VANDER MEULEN **APPEAL OF CONLEY LOT SPLIT**

Santa Barbara County **Board of Supervisors**

February 12, 2008

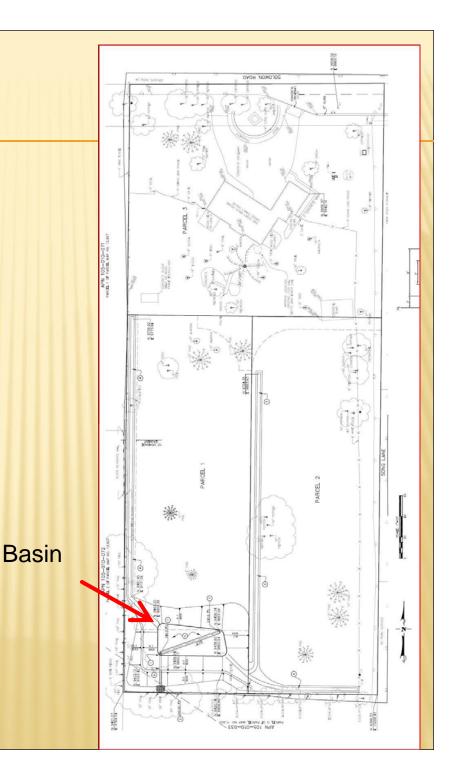
Flooding resulting from post-development runoff

Erosion resulting from basin overspill

Well Contamination resulting from basin overspill

STAFF RESPONSE: FLOODING AND EROSION

Retardation basin is based on grading & drainage study and engineered for 100-year storm event

In the event of overspill, sheet runoff would not cause erosion

Basin would reduce runoff below historic volumes
